BETTER APARTMENTS DRAFT DESIGN STANDARDS

Breathe Architecture Response

Typical Floor Plan

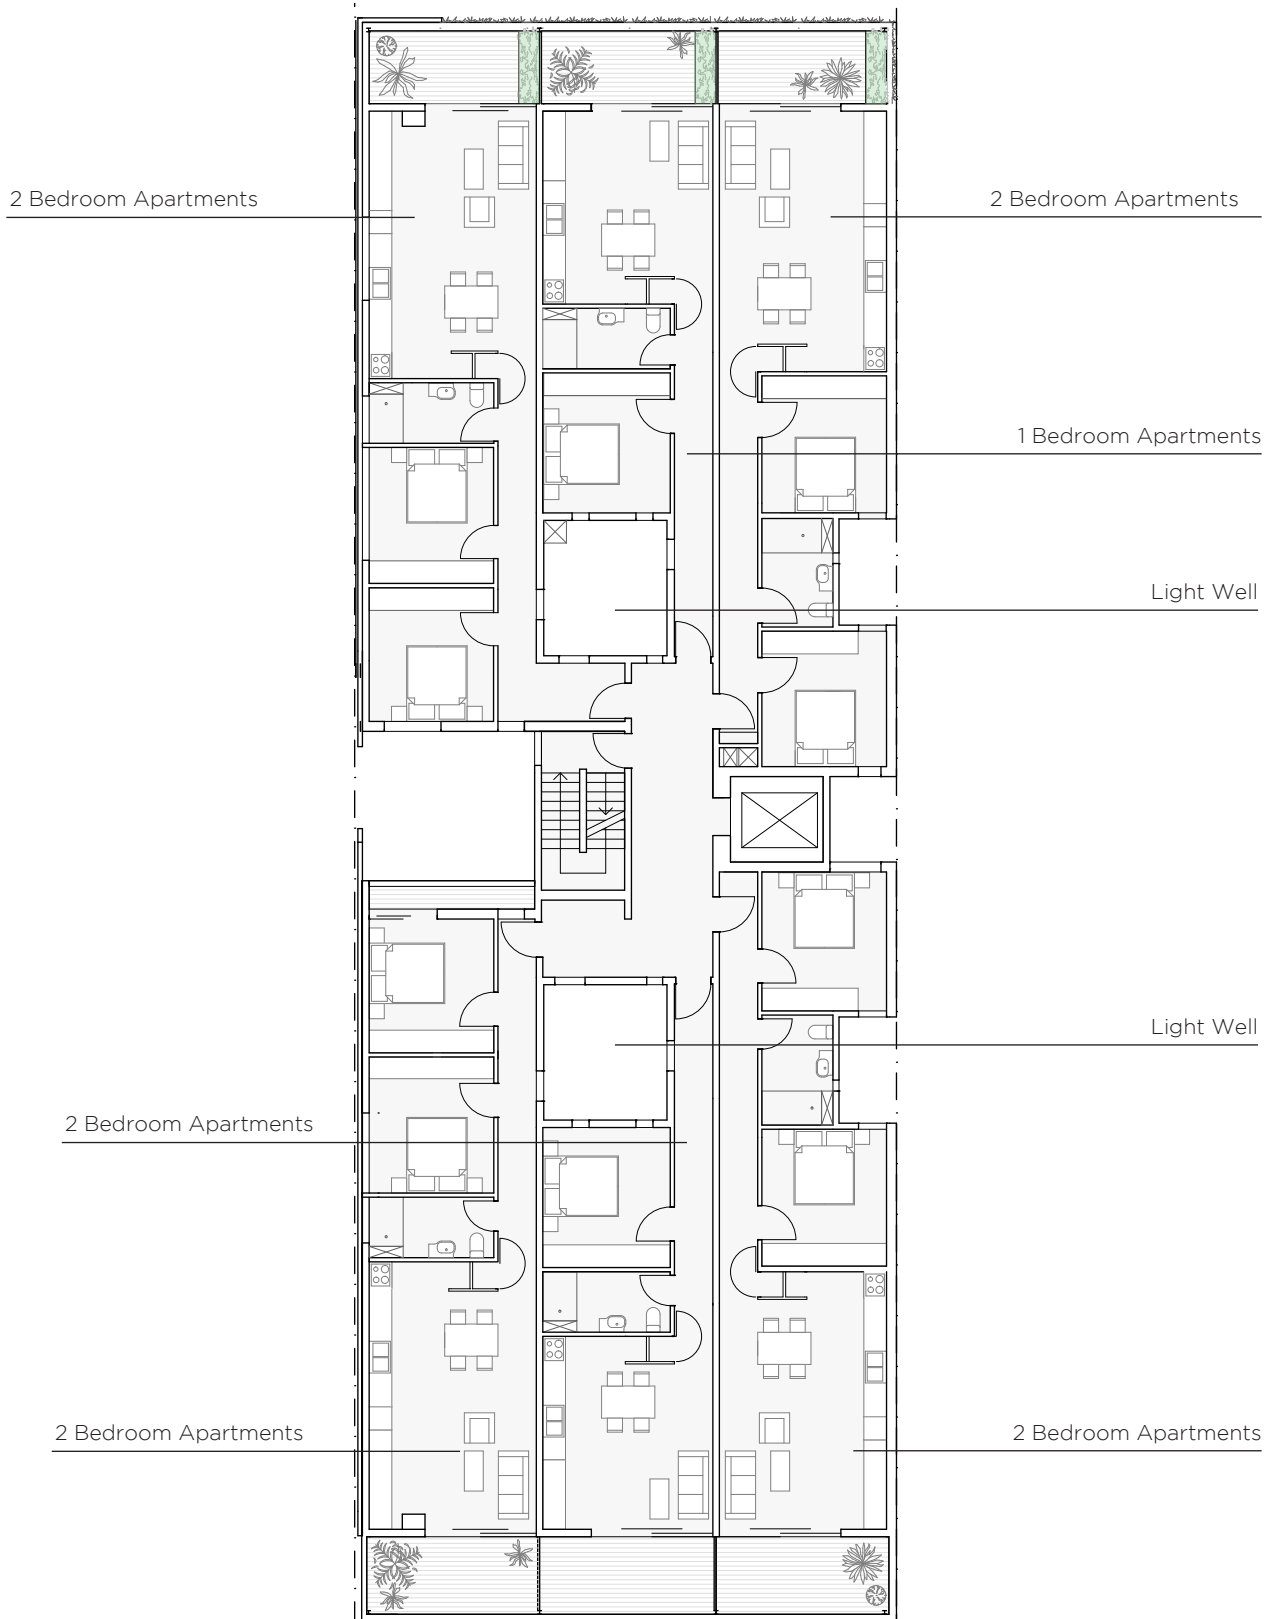
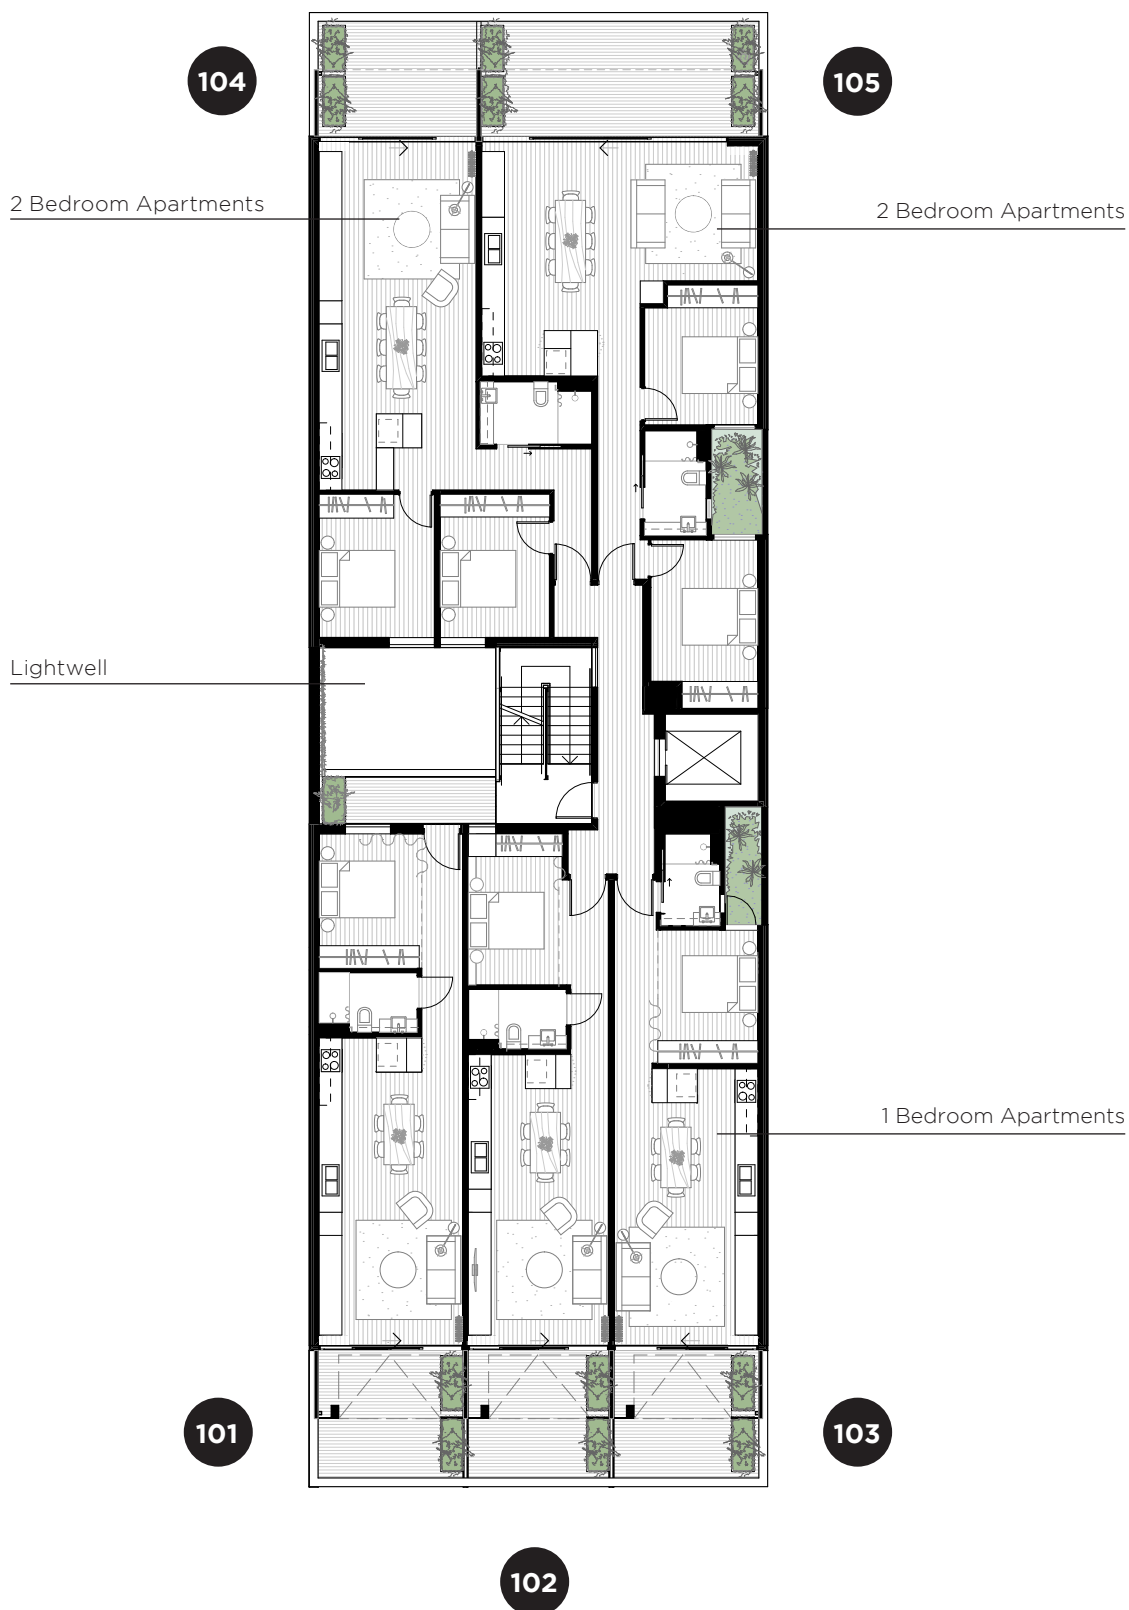
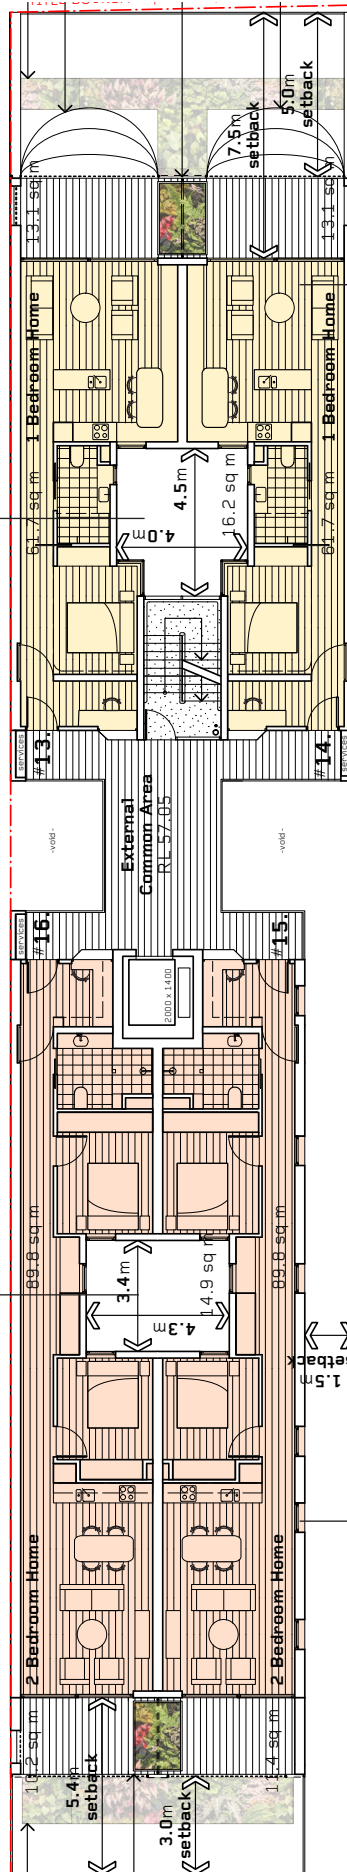
Design Standard: Maximum Habitable Room Depth Ratios

Concern: We understand the need for bringing in regulations for small apartments, however this should not apply to apartments with minimum sizes and ceiling heights over 2.8m.

We are trying to deliver a terrace housing model via a vertical village - spacious apartments (50sqm minimum for 1BR, 75sqm minimum for 2BR and 90sqm minimum for 3BR) that face outwards to the street.

Deep Plans

- 01. Design Standard minimum balcony depth of 2m does not consider basic passive solar design
- 02. North facing balconies at The Commons
- 03. 1.8m deep balconies at The Commons considers basic passive solar design

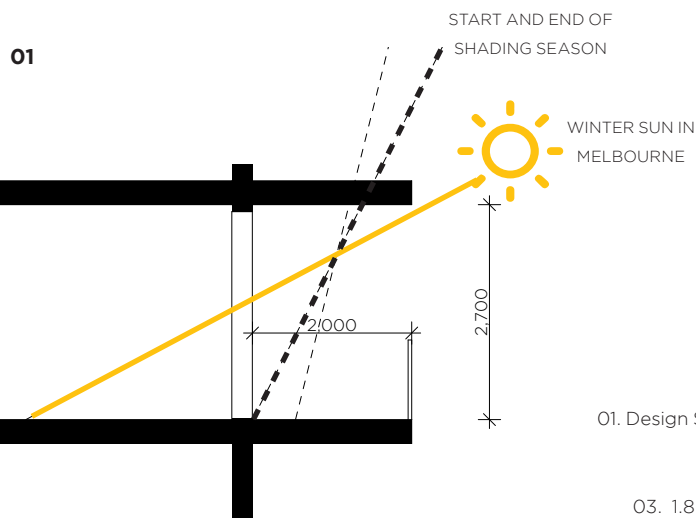
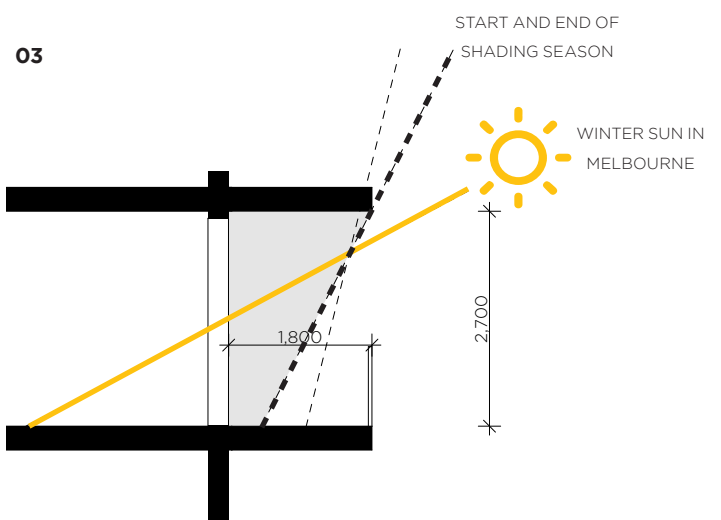
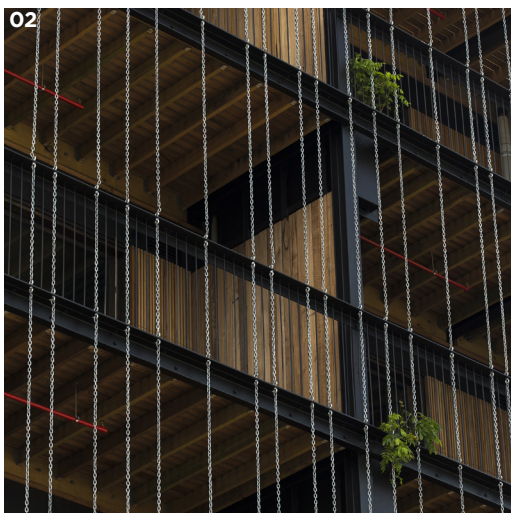
Design Standard: Minimum depth of 2 metres for balconies

Concern: What this means for North facing balconies, specifically in regards to daylight and passive solar design to the affected living areas. The Commons north facing balconies consider and allow for basic passive solar design with 1.8m deep balconies. Balcony depths should be flexible, depending on location and orientation so that they allow for shade at the start and end of shading season and allow winter sun to penetrate into the affected living spaces.

01. Juliet Balconies in Rome
02. Juliet Balconies in Barcelona
03. Juliet Balcony diagram

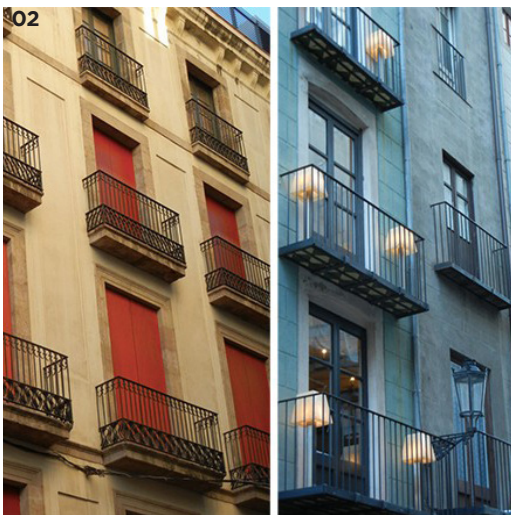
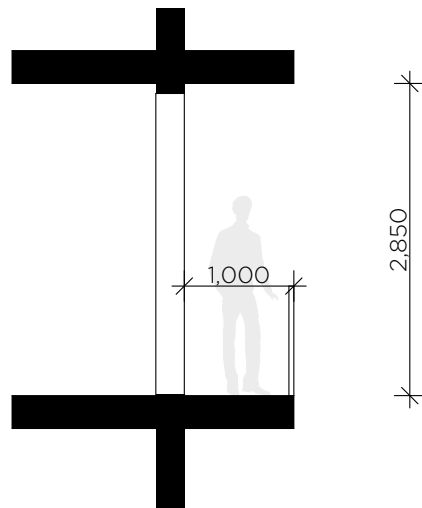
Depending on the orientation and location, Juliet balconies are sometimes best suited, particularly from an ESD and Thermal Comfort perspective. There is currently no mention of Juliet balconies in the Draft Design Standards and we believe that there should be flexibility to incorporate these types of balconies in scenarios where they are more suitable.

01. Bike parking allocation per apartment at
The Commons
02. Bike Parking at the Commons

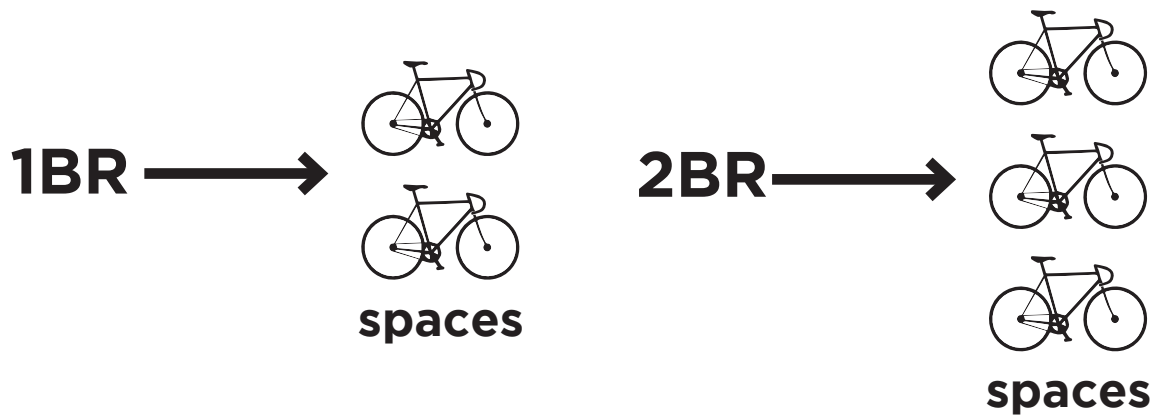
A standard should be set in relation to minimum bike parking. For sites within a 10km radius of the CBD, there should be a minimum of 1 bike park per apartment. This bike parking should be accessible and distinct from storage spaces.
